Potential Environmental Impacts (DEIS Section 3.0)

Section 3.1 Soils and Geology

Figure
3.1-1

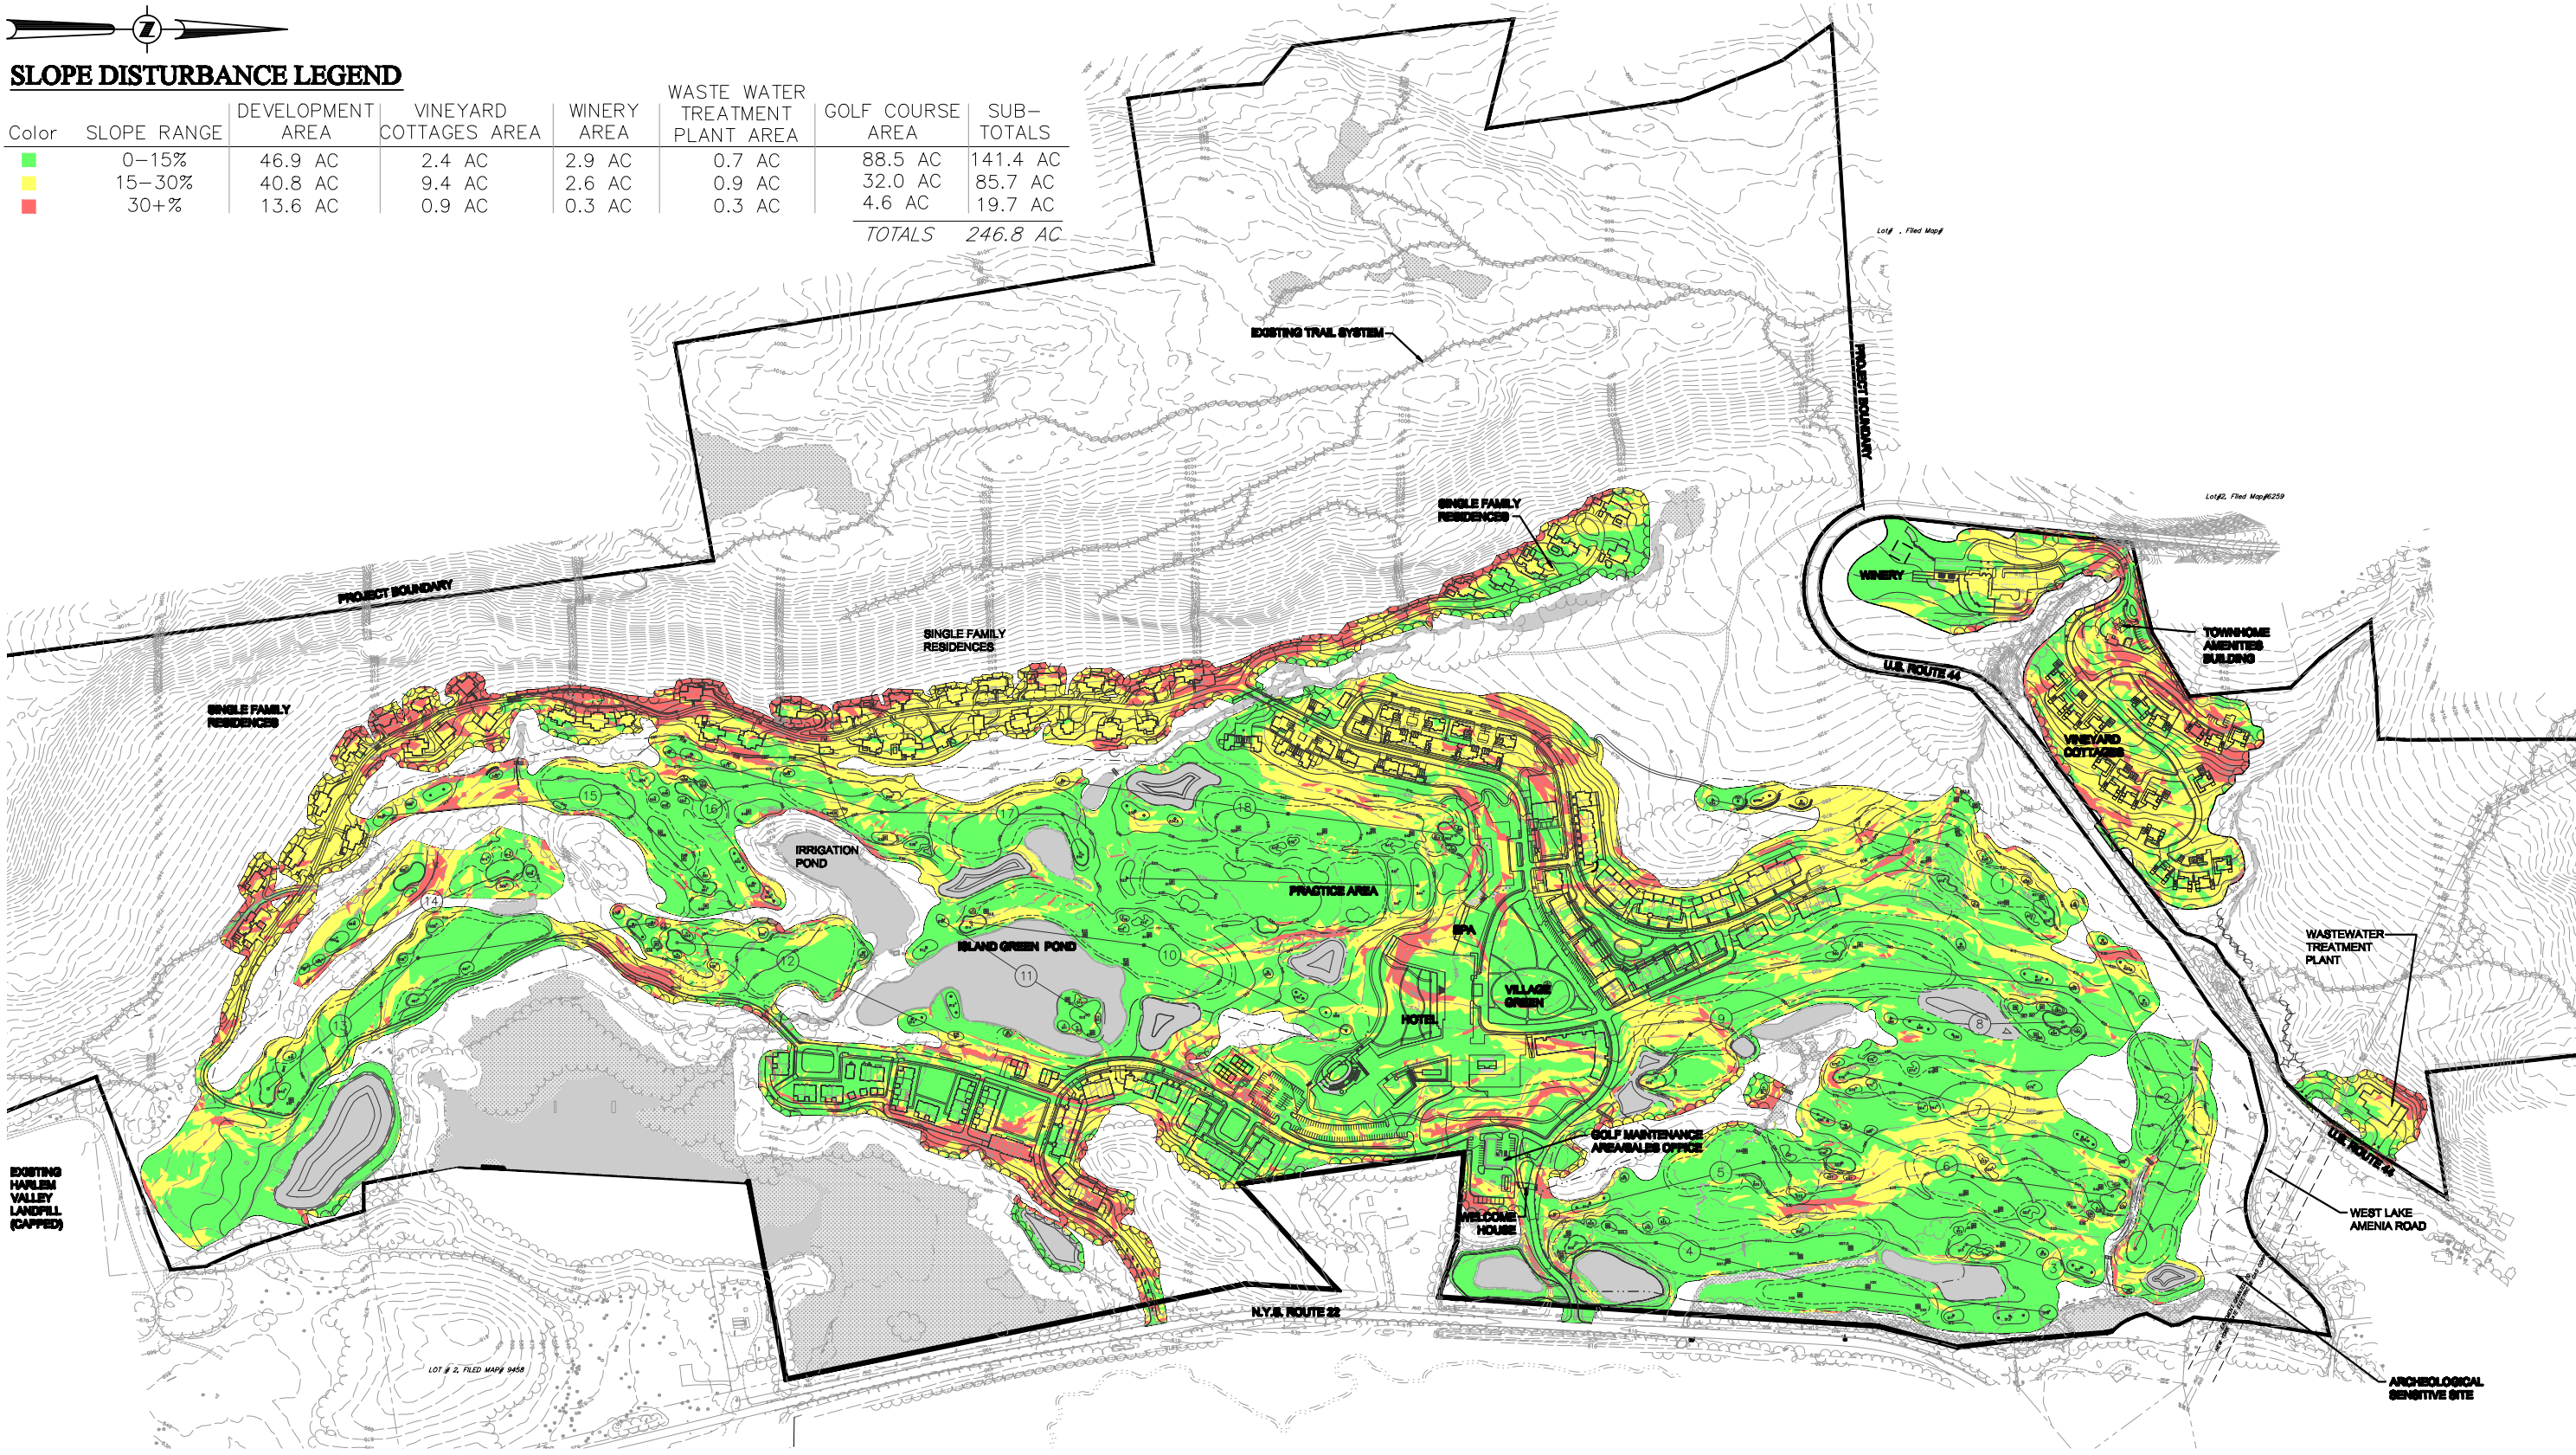
Comment 3.1-5-GP33: For the preferred alternative, slightly less than ½ of all the land (108 acres out of 248 acres) to be disturbed falls into a "steep slope" category (15%+). The applicant needs to explain how this is consistent or inconsistent with the purposes of the RDO in terms of environmental resources. While the applicant has correctly identified potential impacts such as mudslides, houses sliding downhill, rockfalls damaging homes and erosion concerns, they have not clearly detailed mitigation to address these potential impacts. There should be a full description of potential engineering solutions which minimize the potential impacts. It is not enough to say "employing best design, engineering and construction practices will deal with potential hazards..." Mitigation needs to be clearly

articulated so the Lead Agency may evaluate if the mitigation is sufficient to minimize the impacts. [Greenplan, Inc., Letter, April 6, 2008, Comment #33, page 6]

Response 3.1-5-GP33: The April 2008 MDP has reduced the extent of “steep slope” category (15%+) to 105 acres out of a total 246 acres disturbed. Of the 105 acres, 68 acres disturbance results from structural development and the remaining 37 acres from golf course re-development on prior disturbed land. Appendix M, “April 2008 Master Development Plan,” contains Sheet ENV-1, which illustrates the existing conditions with slopes greater than 30%. This map indicates that there are approximately 183 acres with slopes greater than 30%. Figure 3.1-1, “Slope Disturbance by Slope Category and Location,” illustrates the amount of disturbance that will occur on each category of slope (0-15%, 15-30%, and greater than 30%) and further breaks down the information by area of the site. This figure indicates that there will be approximately 20 acres of disturbance to slopes greater than 30%.

To reduce impacts to 30% slopes or greater the Applicant prepared a Mitigation Plan which moves Single Family Homes located along the base of the areas where slopes are less than 30% further to the south. Please see Figure 3.1-2, “Response Plan – 30% Slopes Alternative”. Twelve homes that had portions of their footprint located within 30% slopes were re-located further south in areas where slopes are less than 30%. This plan achieves the same program density as the Preferred Action and reduces the impacts to slopes greater than 30%. Tree clearing would also be reduced by approximately 0.9 acres. However, impervious surface coverage increases with this Mitigation Plan as the development is spread over greater areas of the site. Due to a re-alignment of the drive servicing the single family homes in Block L a second stream crossing is required but impacts to the area along Stream J are also reduced by 800 linear feet. Please also see Response 2.2-2-PHT.
